CHANGES FROM SCHEME PERMITTED UNDER ABP-307415-20 - FOURTH FLOOR

**PROPOSED
FOURTH FLOOR**

LISIEUX PARK

Notes 1. Copyright Reserved 2. Work to figured dimensions only. Do not scale drawing. 3. The contractor is responsible for checking all levels and dimensions on site and shall refer all discrepancies to the Architect. 4. Where appropriate, for details of r.c. structure, or mechanical and electrical details, see Engineers drawings. 5. Proprietary items shall be fixed in strict accordance with manufacturers instructions. 6. Sizes of proprietary items shall be checked with manufacturer. 7. The contractor shall be responsible for the coordination of structure, finishes and services.		Issue Status Progress Planning Application Fire Cert Disability Cert Tender Construction As Built Information Only		No. Date Revision P03 06.10.2023 Planning Permission Application - General Amendments		Initials MC
Project RESIDENTIAL APARTMENTS, LISIEUX PARK Murphystown Road, Leopardstown, Dublin 18		Drawing Title Proposed Fourth Floor Plan		Scale 1:200@A1		Date 03.04.2023

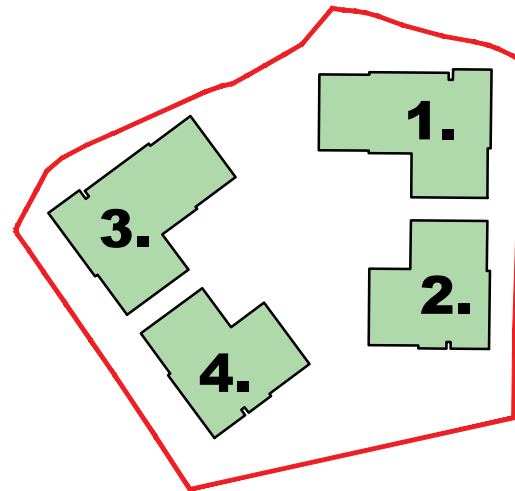
RECONFIGURATION OF LIFT/STAIR CORES TO COMPLY WITH DAC/FSC REQUIREMENTS.

EN-SUITES REMOVED FROM ALL 2 BED UNITS TO ALLOW SPACE FOR APARTMENT FRONT DOORS TO MOVE CLOSER TO THE PROTECTED CORES AND COMPLY WITH THE FSC.

CORRIDOR LENGTHS REDUCED AND DOORS MOVED CLOSER TO CORES TO ALL GABLE 2 BED UNITS TO SATISFY TRAVEL DISTANCES TO SUIT FSC.

ALL PERMITTED BEDROOM DOORS OPENING ON TO BALCONIES CHANGED TO WINDOWS TO IMPROVE SAFETY AND SECURITY.
